Access Compliance Report

Public Rights-of-Way

(Curb Ramps)

Intersection ID: 52487	Main Street: WHITEHALL EXECUTIVE CENTER DR	Cross Street: ORLICK DR	Location: E
ADA ID: 31E15FB65E7E	Ramp Type: Perp	Initial Pass/Fail: Pass	Overall Compliance: No
Severity Score: 2.5			
Codes/Mitigation Info/Possible Solution		Field Measurements/Component Compliance

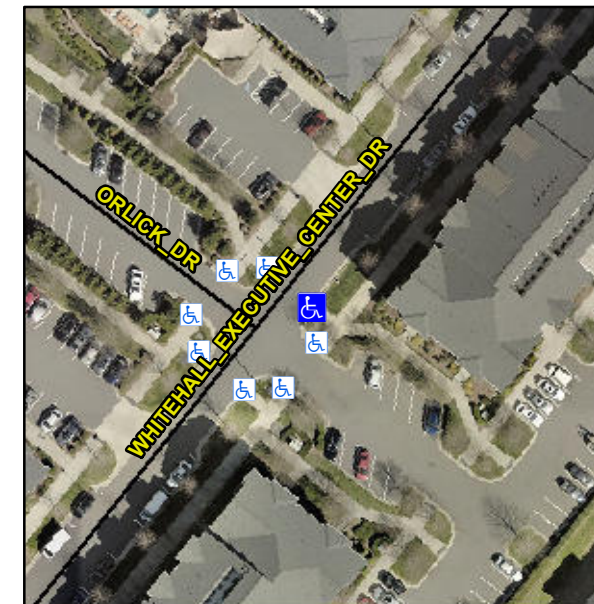
**R304.2.2-Perp, R304.3.2-Para,
R305.1.4**

Compliance	Description	Data	Compliance	Description	Data
N/A	Ramp Length (in)	70.0	Yes	Ramp Slope (%)	5.7
Yes	Ramp Width (in)	70.0	Yes	Ramp XSlope (%)	1.6
Yes	Flare Type LT	Curbed_NoWalkSurface	Yes	Flare Type RT	N/A
Yes	Flare Slope LT (%)	N/A	N/A	Flare Slope RT (%)	N/A
N/A	Flare Traversable LT?	No	N/A	Flare Traversable RT?	No
Yes	Landing Length (in)	80.0	Yes	DWS Provided?	Yes
Yes	Landing Width (in)	71.0	Yes	DWS Contrast?	Yes
No	Landing Slope (%)	4.0	Yes	DWS Length (in)	24.0
Yes	Landing X Slope (%)	1.4	No	DWS Full Width?	No
N/A	Landing Curb? (Y/N)	No	Yes	DWS Offset (in)	0.0
N/A	Shared Landing?	No			
Yes	Gutter Ponding?	No	Yes	Gutter Slope (%)	0.8
Yes	Gutter Lip Ht (in)	0.0	Yes	Gutter X Slope (%)	1.2
N/A	Painted X Walk1?	No	N/A	Painted X Walk2?	N/A
	X Walk 1 Direction	To NW		X Walk 2 Direction	N/A
N/A	X Walk 1 Width (in)	N/A	N/A	X Walk 2 Width (in)	N/A
	X Walk 1 Slope (%)	3.4		X Walk 2 Slope (%)	N/A
	X Walk 1 X Slope (%)	2.2		X Walk 2 X Slope (%)	N/A

N/A	Ramp inside XWalk1?	N/A	N/A	Ramp inside XWalk2?	N/A
	Road Slope (%)	N/A	N/A	Clear Space?	Yes
	Road X Slope (%)	N/A	N/A	Clear Space to XWalk (in)	N/A
Yes	Any Obstructions?	No	Yes	Storm Grate/Utility Hazard?	No
	Obstruction Type			Storm Grate/Utility Type	
		N/A			N/A
			Yes	Surface Condition? (G/P)	Good

Remove & Replace Entire Ramp.
